# Technical Document LA24030

Application under the *Agricultural Operation Practices Act* for a confined feeding operation, manure collection area, and/or manure storage facility(ies)

<b>NRCB USE ONLY</b>		Application number	Legal land description
<input checked="" type="checkbox"/> Approval	<input type="checkbox"/> Registration	<input type="checkbox"/> Authorization	
<input type="checkbox"/> Amendment		<u>LA24030</u>	SW 8-22-20 W4M, SE 12-22-21 W4 N½ 7-22-20 W4M

**Re:                   Geotechnical Review and Evaluation  
                      NRCB Permitting of Pens and Catch Basins  
                      NE-07-022-20-W4M, near Cluny, Alberta**

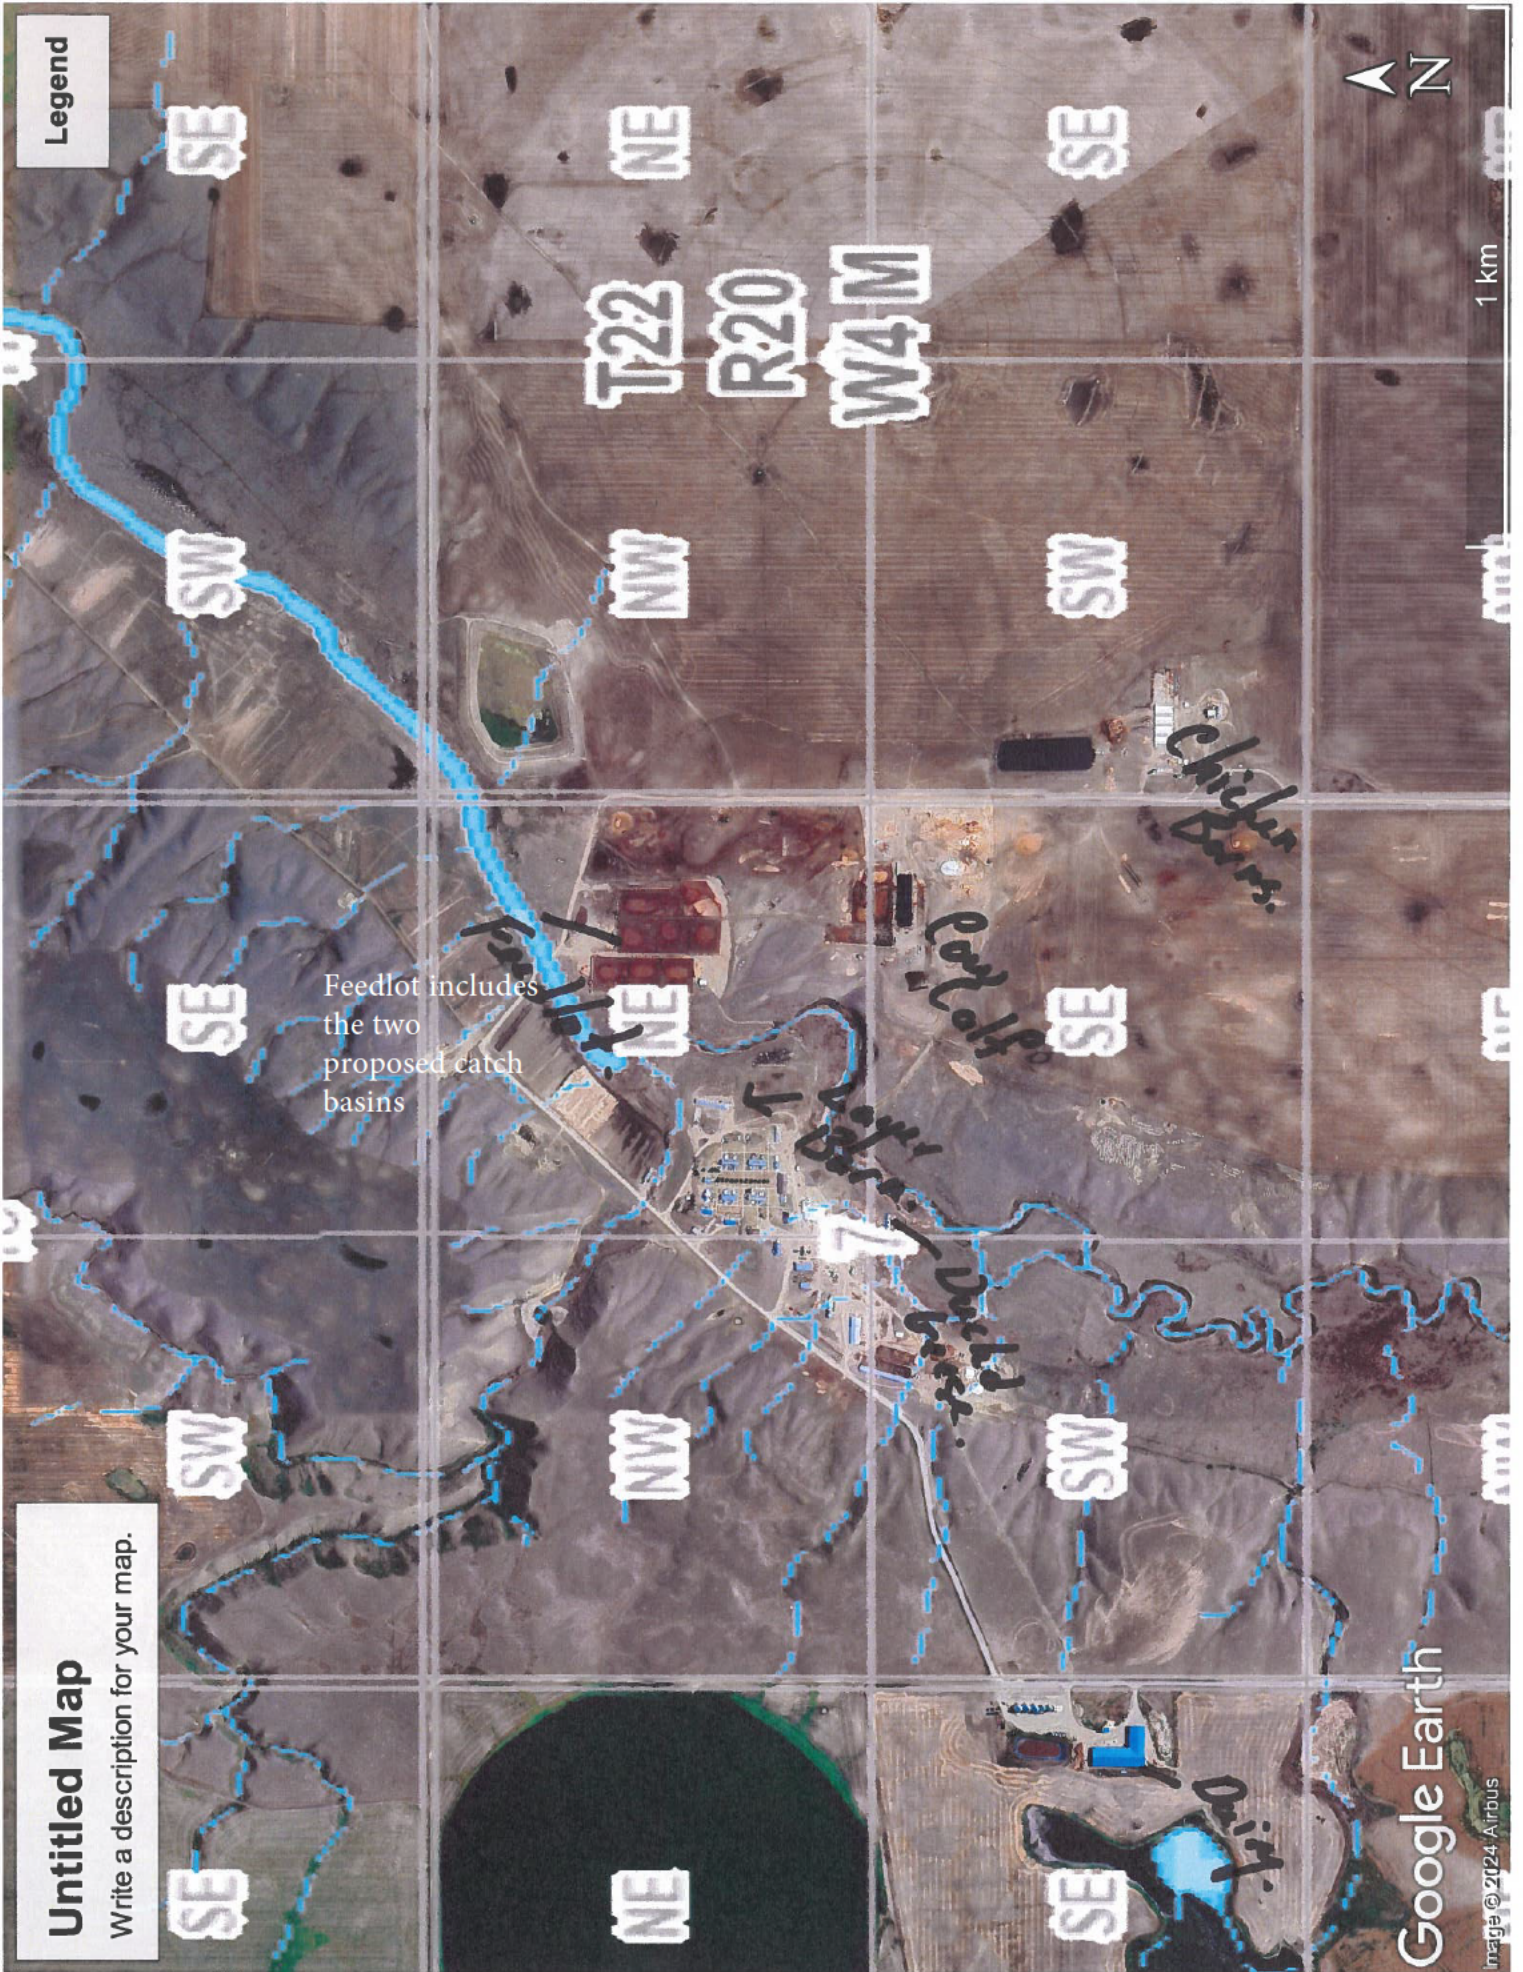
AO comment: All existing facilities have been confirmed
